Certified Action of the City of Raleigh Planning Commission

Case File / Name: SP-14-09 / Leith Mercedes Benz Expansion

Nature of Case: This request is to approve the addition of a 12,640 square foot one story service bay facility, a 8,522 square foot sales/showroom and 235 parking space expansion to an existing automotive sales and service facility on an 11.45 acre site (Lot 3 BM 2009 PG 159), zoned Industrial-1) The proposal includes the demolition of an 8,857 existing automotive sales/showroom.

Staff Report

SP-14-09 Leith Mercedes Benz Expansion – Site Plan

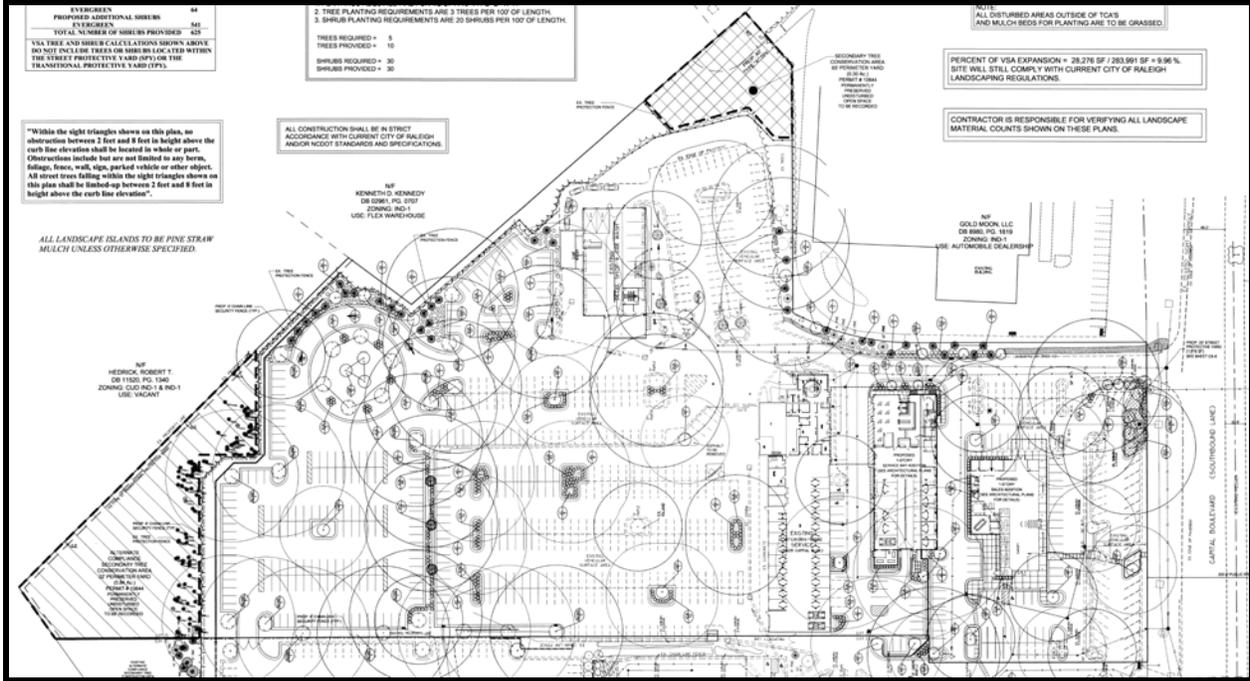
<u>Comment</u>	<u>Response</u>
1. The Development Review Committee recommends that, given the relative elevation of the subject area, that the maximum height of the new light poles be 20 feet, and that all fixtures be of full cutoff (shielded) design.	The maximum height of the new light poles will be 20' and the fixtures will be of full cutoff (shielded) design.
2. To tie the building closest to Capital Boulevard both symbolically and practically to the street, a direct, straight-line pedestrian connection should be made from its front entrance to the street right-of-way.	A Pedestrian connection was created from the front entrance of the building to the street right-of-way.

CIRCULATION: The proposal shows one access point on Capital Boulevard and a 25' cross access easement to lot 2, the adjacent parcel to the south (BM1997 PG 0879).

PEDESTRIAN: There exists an internal sidewalk linking the proposed sales/showroom to the property line along Capital Blvd and an additional sidewalk connection to the adjacent Leith BMW Site to the adjacent south. Sidewalk does not exist on this portion of Capital Boulevard where a fee in lieu of sidewalk construction was previously paid.

- (7) That the maximum height of the new light poles will be 20' and the fixtures will be of full cutoff (shielded) design;
- (8) That a tree conservation map be recorded with metes and bound showing the designated Tree Conservation Areas prior, to issuance of building permits. Tree conservation shall be in compliance with Code section 10-2082.14 and a copy of the recorded plat must be provided to the Site Review Specialist in the Inspections Department;

- (9) That the 25' cross access easement shown on the preliminary plan between this lot, lot 3, and lot 2 (BM1997 PG 0879) be recorded and be shown on all maps for recording. A copy of the recorded cross access easement shall be provided to the Site Review Specialist in the Inspections Department prior to permit issuance; and
